Introduction

The B3 Brake Return Spring, B3 Brake Piston Rings, and Low Coast Modulator Spring have been changed to improve "Park to Reverse" or "Neutral to Reverse" shift operation.

- LX 450 with A343F transmission.

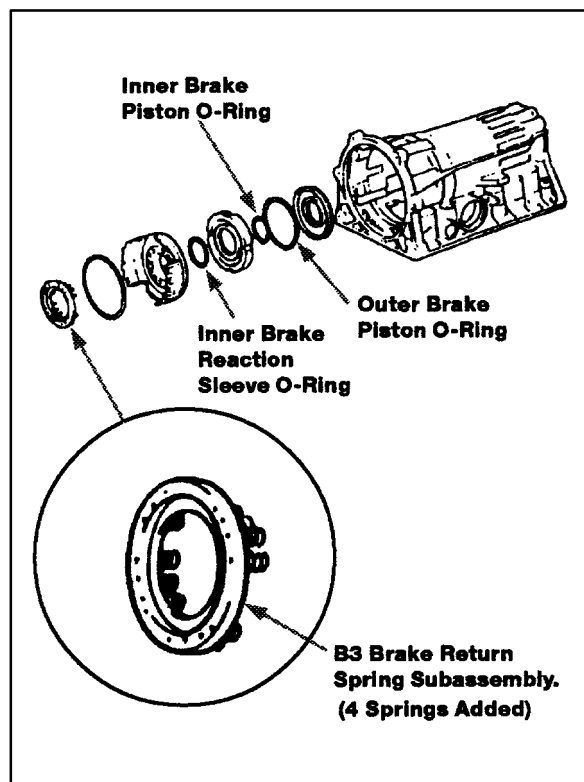
1. Springs were added to B3 Brake Return Spring Subassembly.

PREVIOUS	NEW
Number of Springs	16	20
